RE: New York SMSA Limited Partnership d/b/a Verizon Wireless installation of a public utility personal wireless facility at the property known as 52 Montrose Station Road, Town of Cortlandt, NY

In connection with the Facility, we received comments from the Town's Director of the Department of Technical Services, Michael Preziosi, P.E. ("Town Engineer") on March 11, 2019 and the Town's Consultant, The Center for Municipal Solutions ("Town Consultant"), dated April

Response to the Comments from Town Engineer:

DRAWING TITLE:
PRELIMINARY EXISTING CONDITIONS SURVEY
DRAWING NO.: Z10 PAGE NO.: 10 of 11

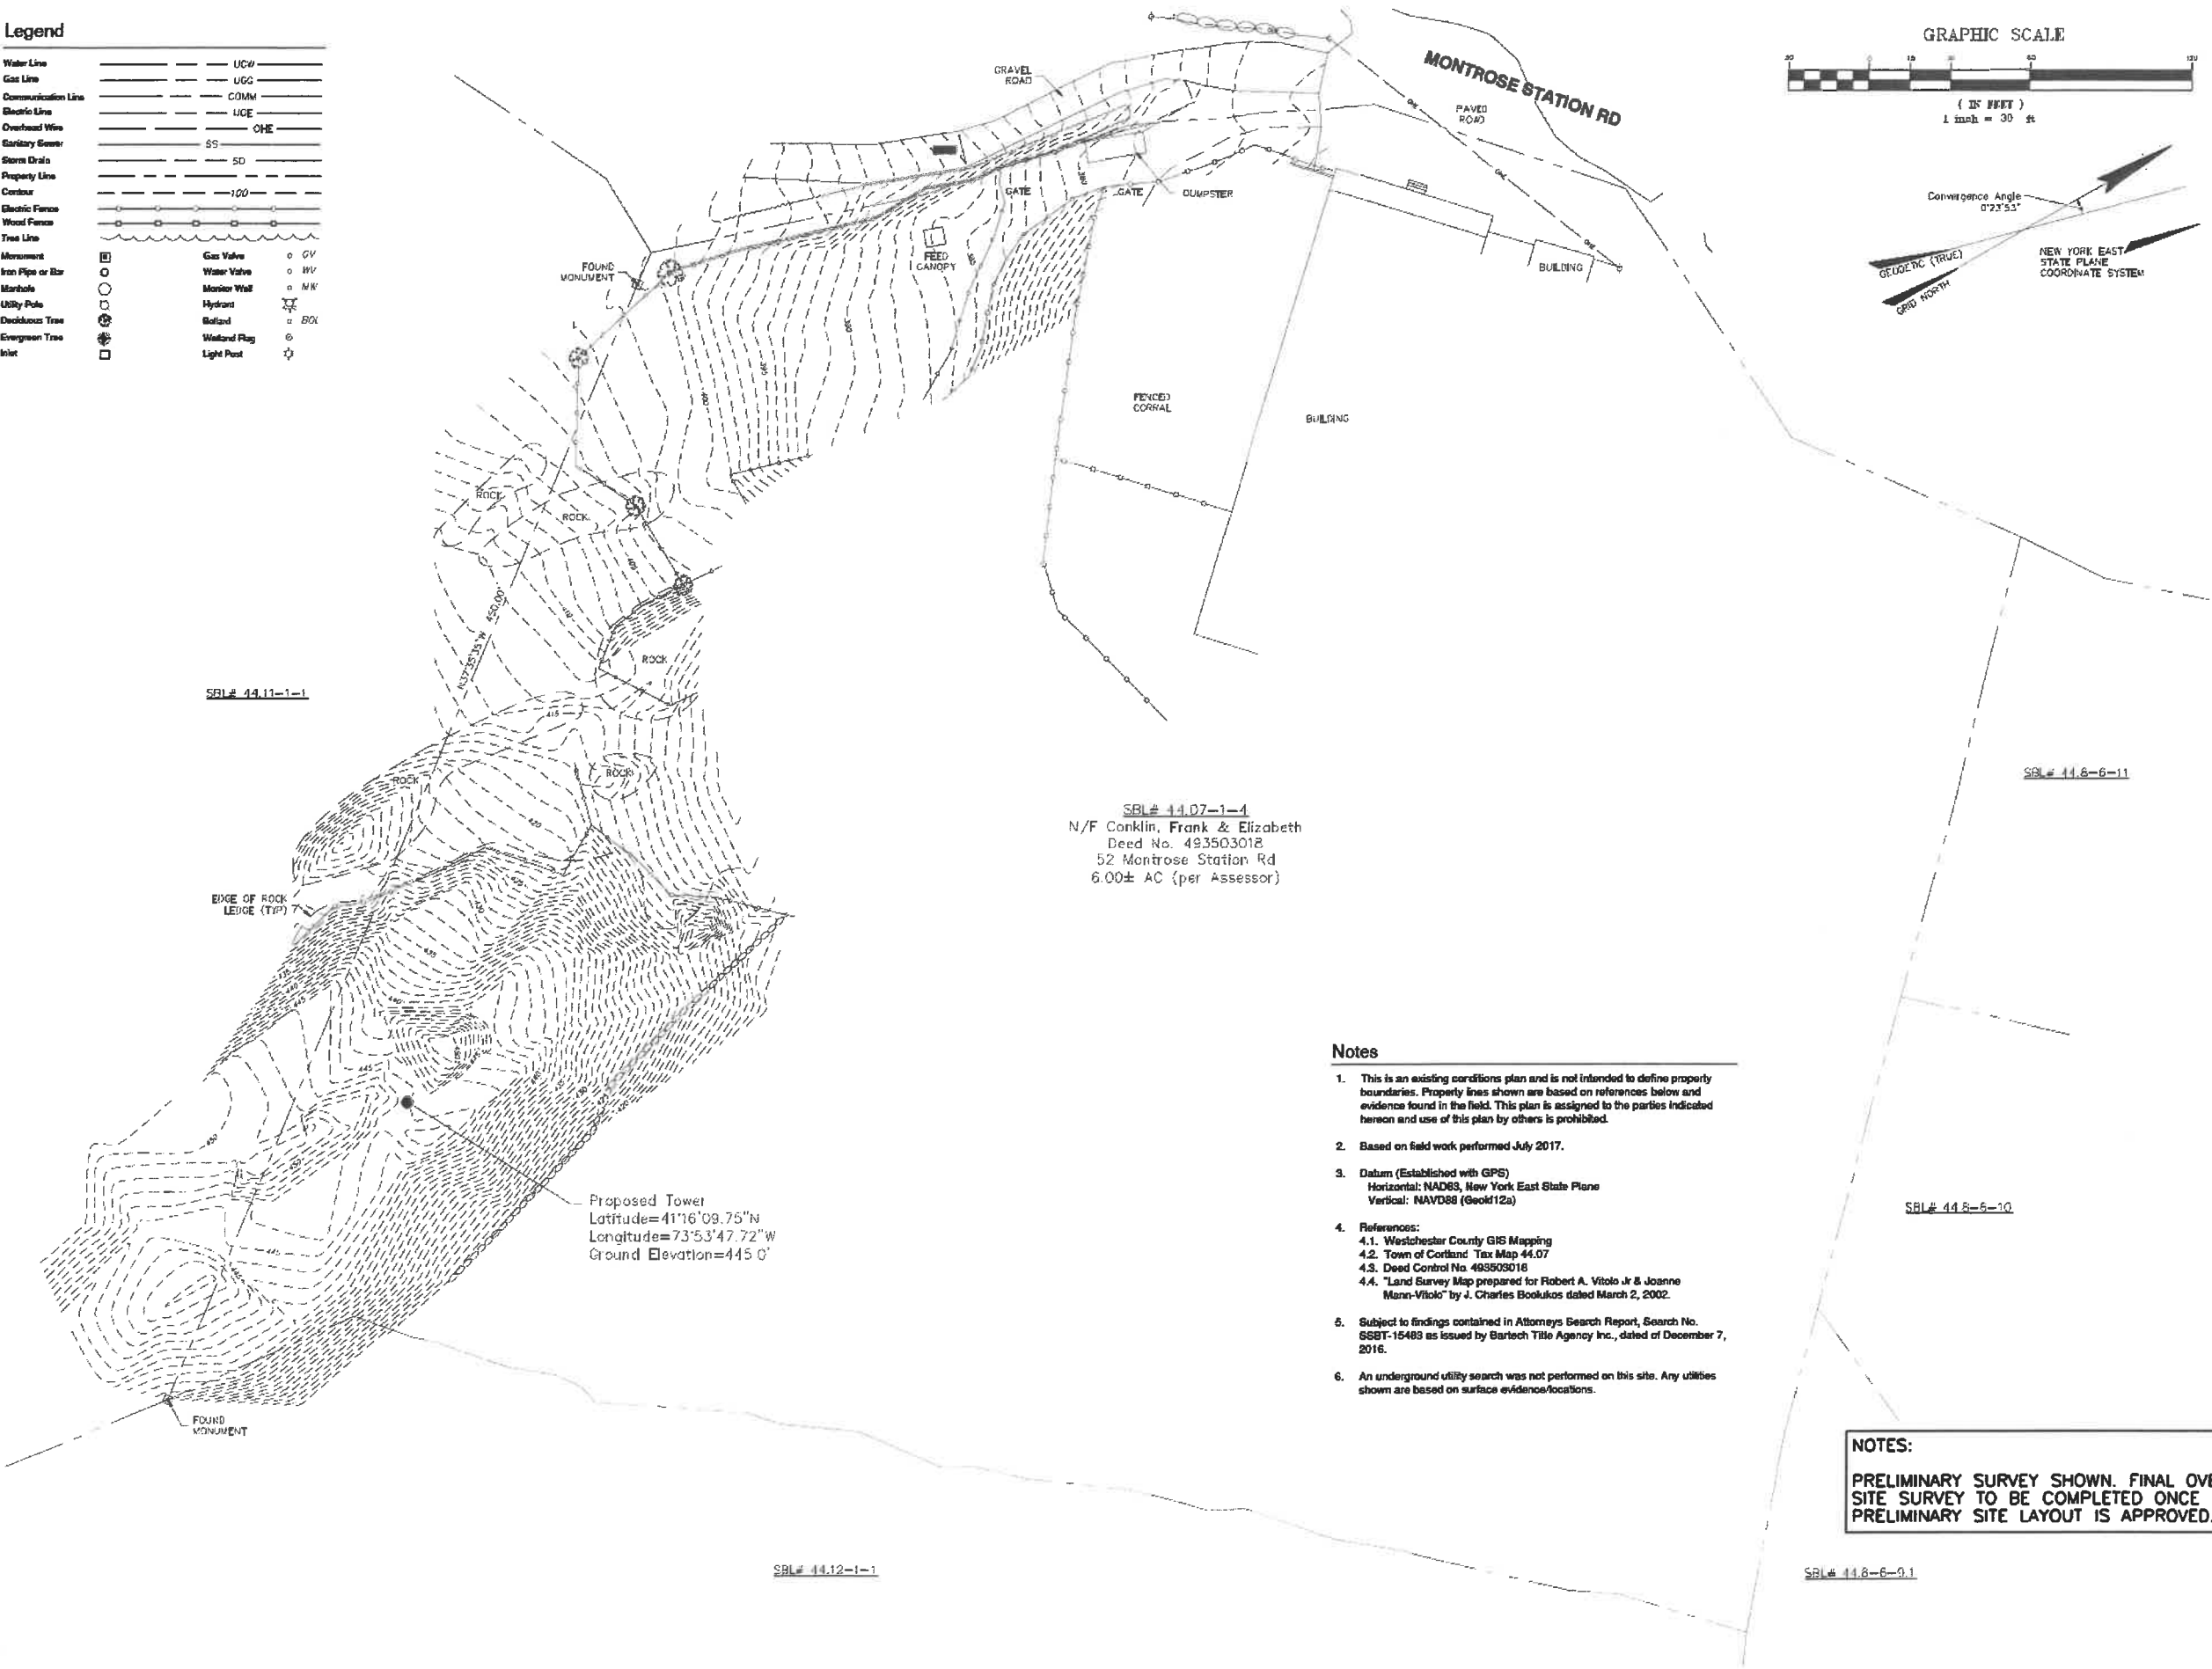
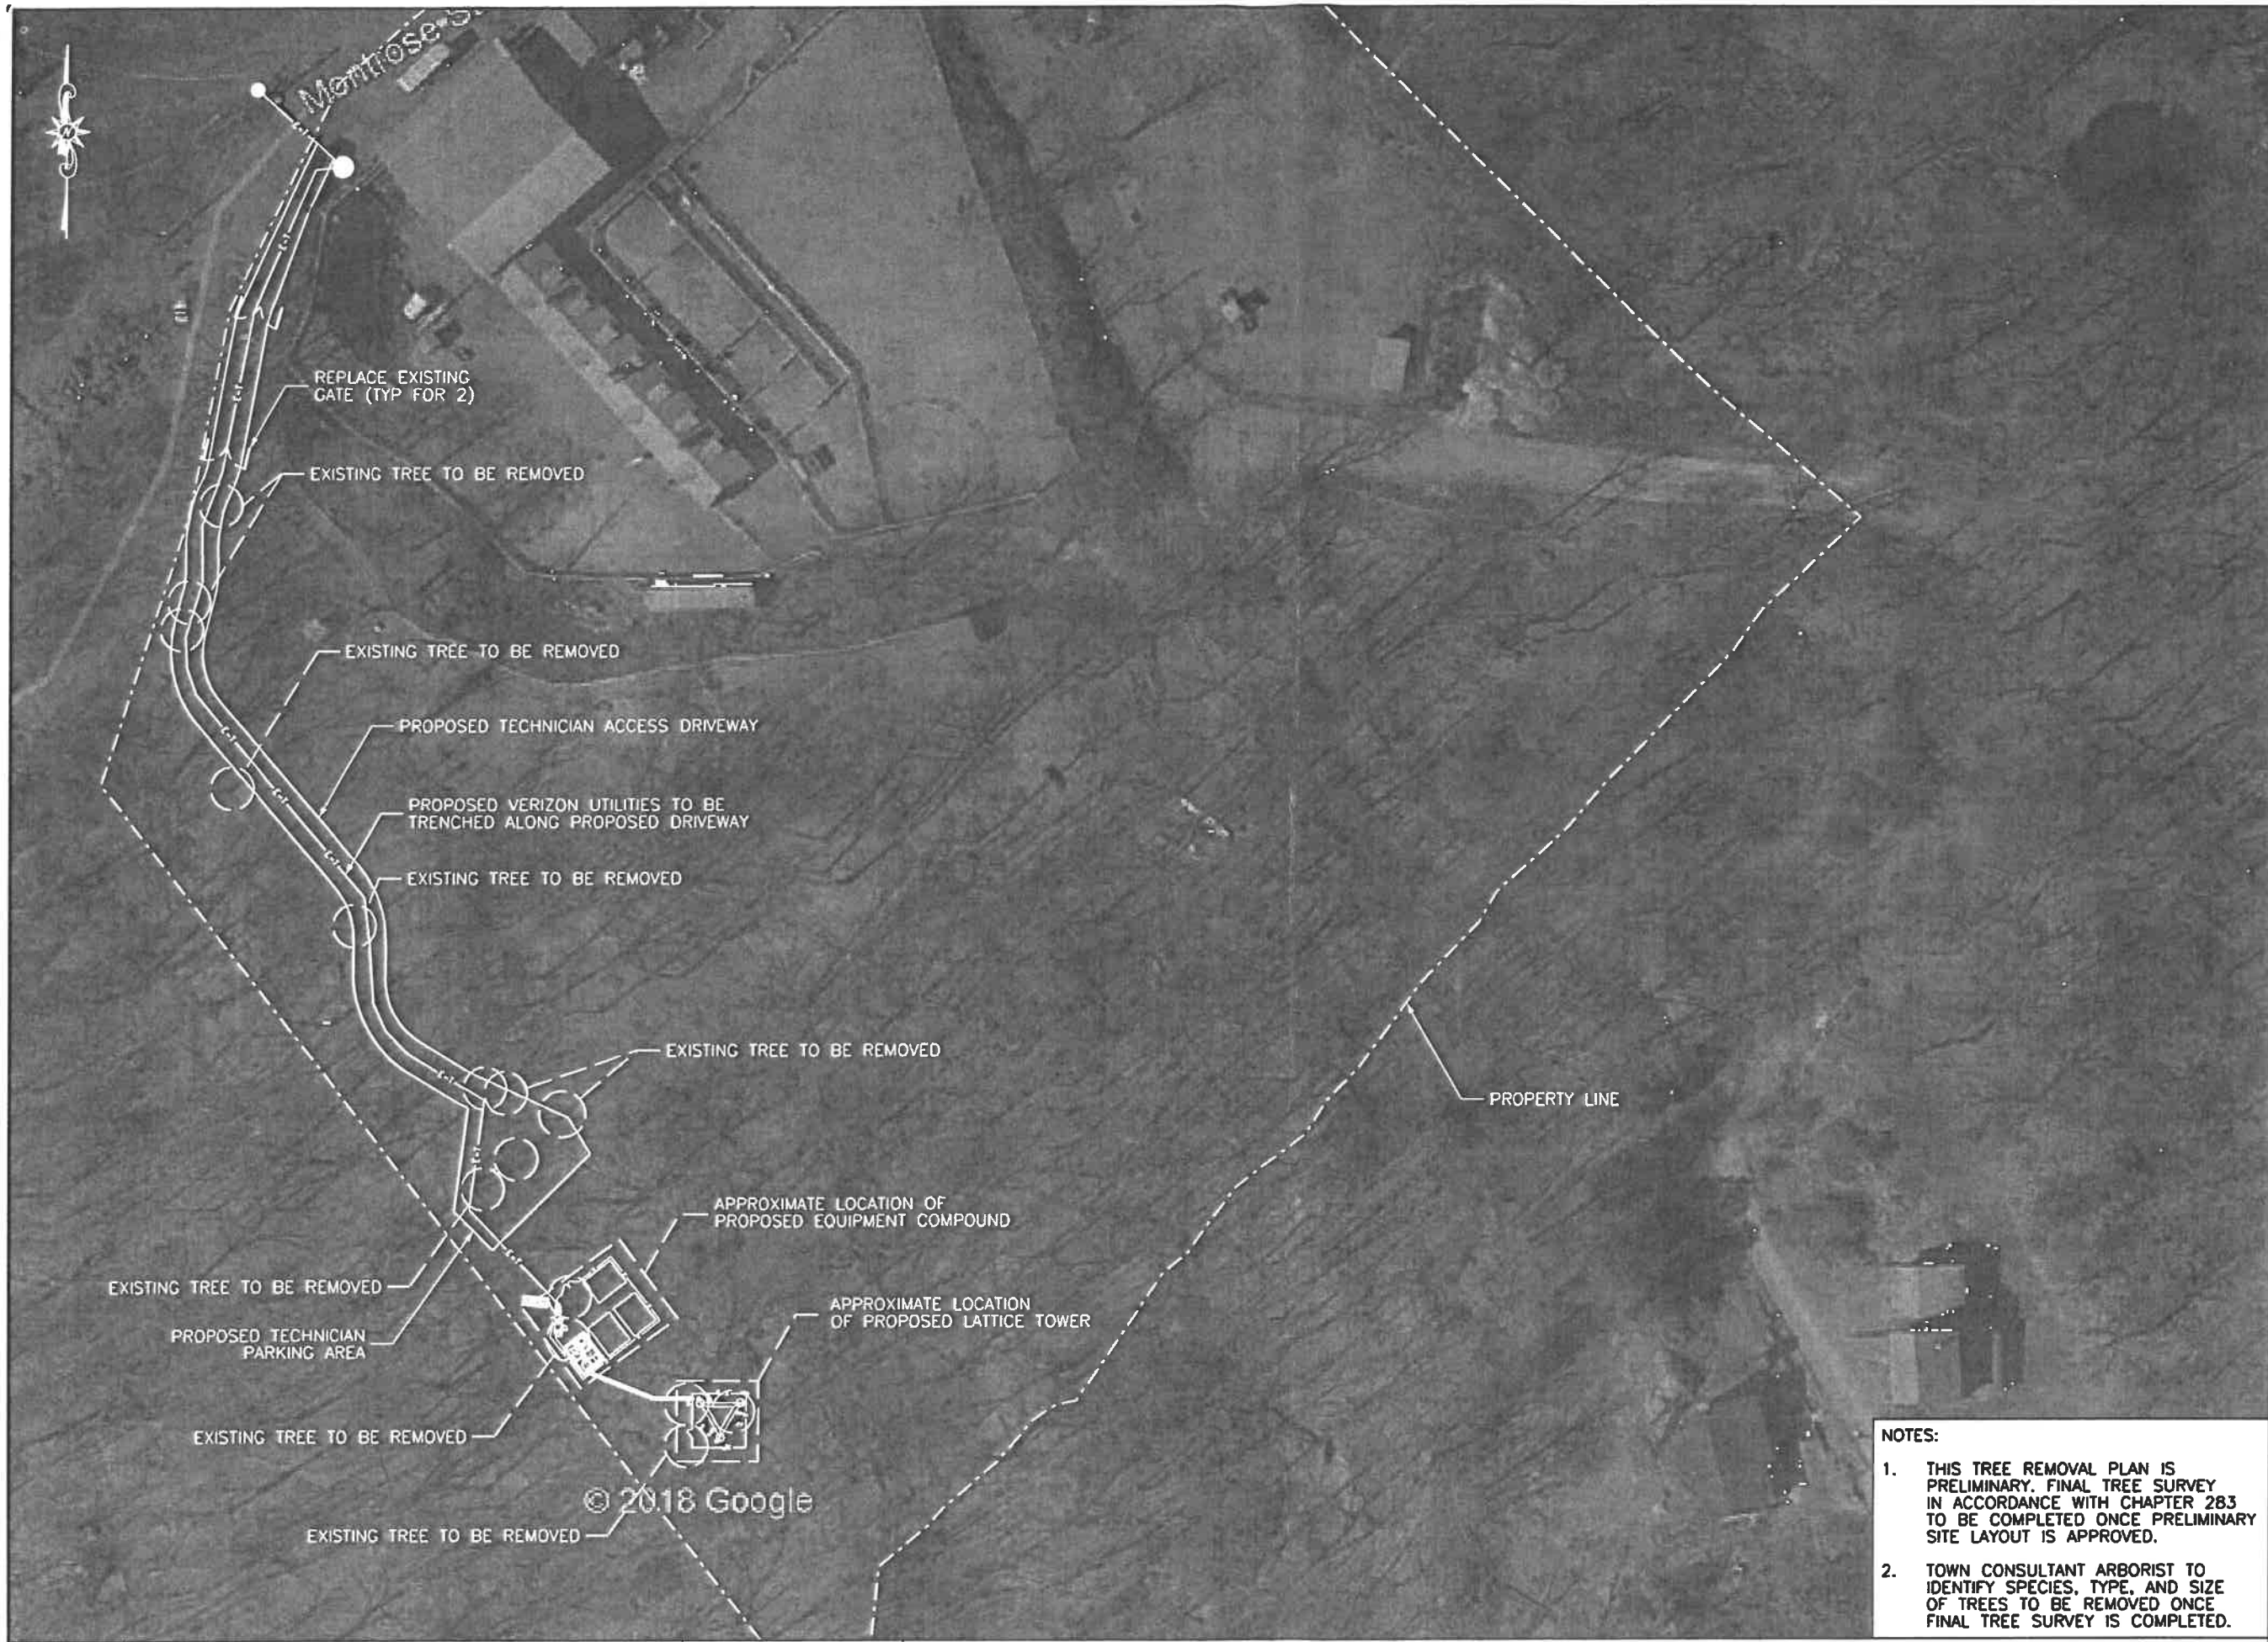
Comment #1: *The submission lacks a property survey prepared by a licensed NYS Professional Land Surveyor. Setbacks to the property line cannot be accurately determined without a survey. The Tower as proposed does not meet dimensional setback requirements to the property line for the equipment pad and tower enclosure.*

Comment #2: *The break point and collapse zone has been improperly identified. The Applicant shall read the definitions of breakpoint and collapse zone in sections 277-4 and 277-6(H) of the Town's ordinance.*

Response: Enclosed herewith are revised plans ("Revised Plans"), last dated July 15, 2019, prepared by Verizon Wireless' project engineer for this Facility, Scherer Design Group ("SDG"). Page Z10 of the Revised Plans is the requested survey. Kindly note that Verizon Wireless has "re-evaluated" the location of the Facility and that based on the topography, location of trees, size and shape of the Property, it determined that the proposed location is the best location for the Facility as it will be behind mature trees, away from the road and away from any neighboring residences, and will provide much needed reliable wireless communications, including wireless 911, to a significant gap in coverage that exists in that area of the Town. As indicated in the memo in support submitted previously: "Z. Setbacks §277-13: The Facility will comply with the all of the setback requirements set forth in Section 277-13, except for an individual side yard setback." In connection therewith, Verizon Wireless will require a variance from the Zoning Board of Appeals. However, the setback variance that Verizon Wireless requires is with respect to the Facility's setback from the Blue Mountain Reservation adjacent to the Property. Therefore, there are no structures in the proximate area and only woods between the Property and the adjacent Reservation, so the variance will have no adverse impact to the area.

- (vi) Pages Z3 and Z10 of the Revised Plans shows field based topography within 100ft. of the proposed limits of disturbance. Additionally, it is respectfully requested that the topographic and geomorphological study within the disturbance limits and a Steep Slope analysis in accordance with Town Code Chapter 259 both be a condition of the building permit, after the location of the Facility has been approved; and
- (vii) Page T1 of the Revised Plans includes a note that the tower owner will maintain the Facility during expected monthly visits and that that the applicant will comply with code requirements regarding abandonment/discontinuance in that unlikely event.
